<b>MAHARASHTRA NATURAL GAS LIMITED</b>	<b>REPLY TO BIDDERS QUERIES AGAINST TENDER FOR RATE CONTRACT FOR THE PERIOD OF 2 YEARS FOR RESTORATION OF ROADS FOR CGD NETWORK OF MNGL, PUNE</b> <b>Bid No.: MNGL/C&amp;P/2017-18/50</b>
---	--

**Replies to Queries of the Bidders**

TYPICAL CROSS SECTION OF RESTORATION OF TRENCHES FOR BITUMINOUS ROAD ( INCLUDING TACK COAT ON TOP OF BM AND DBM

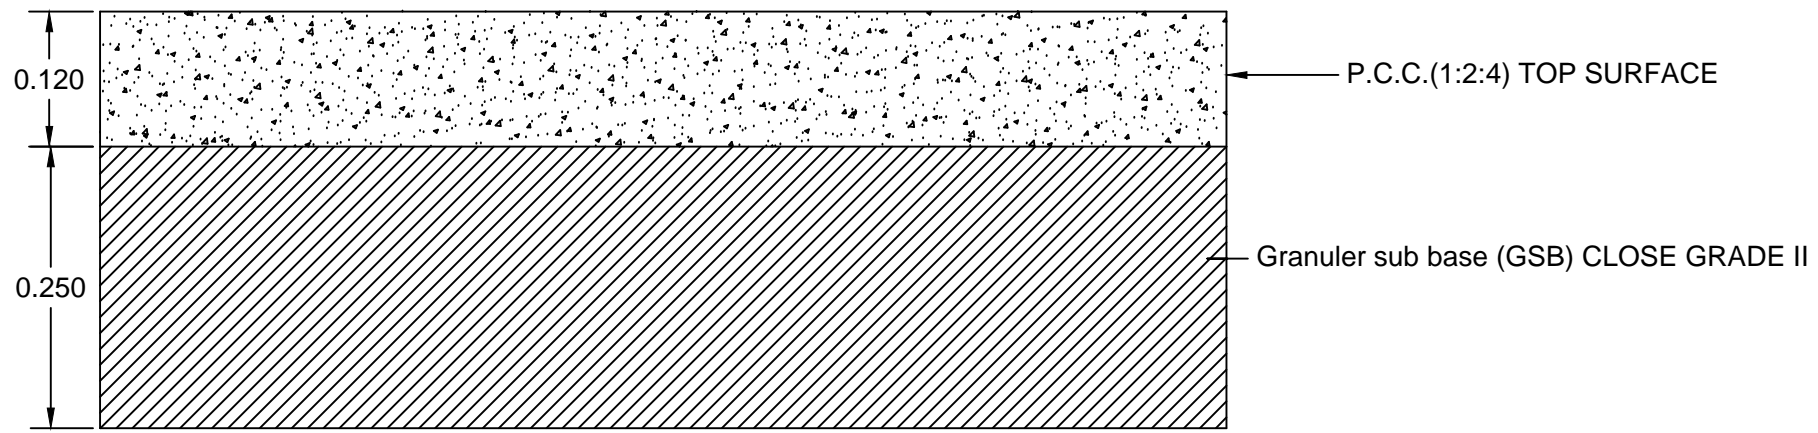
1.	Please specify the width of the restoration	Width of the restoration is 800 mm.
2.	In item no 1: bituminous road point no. ii and iii please specify the layer name and thickness	Please see the attached drawing for typical Cross Section of Restoration of Trenches for Bituminous Road (Including Tack Coat on Top of BM & DBM)

TYPICAL CROSS SECTION OF RESTORATION OF TRENCHES FOR CONCRETE SURFACE

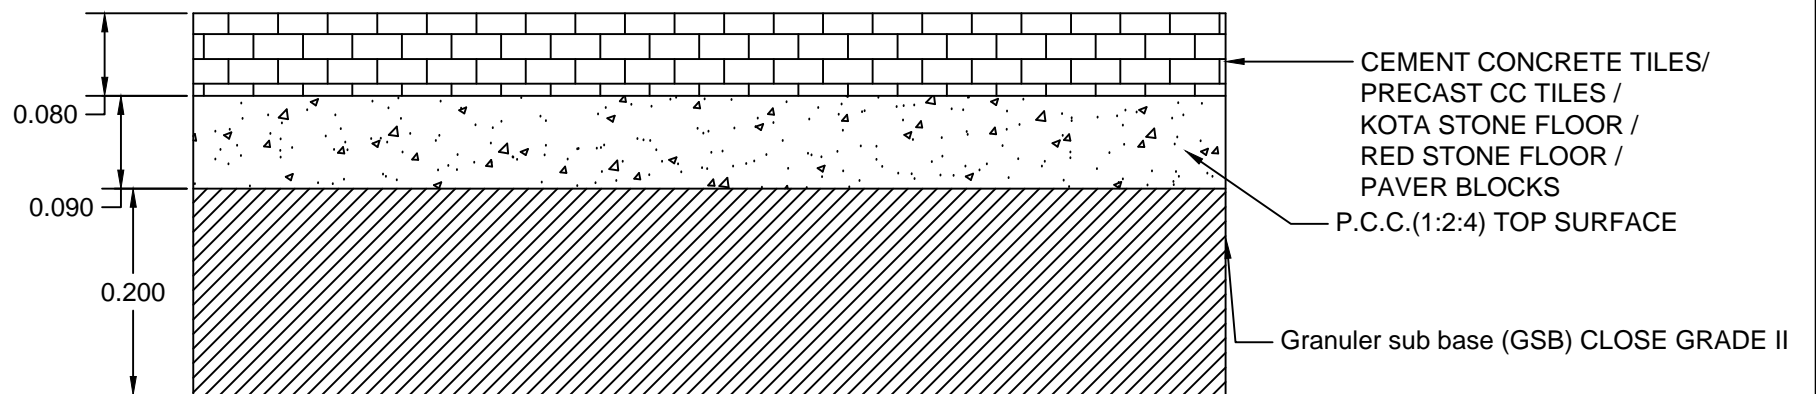
3.	In item no 2: Concrete please specifies the thickness of all layer and layers name.	Please see the attached drawing for typical cross section of restoration of trenches for concrete surface.
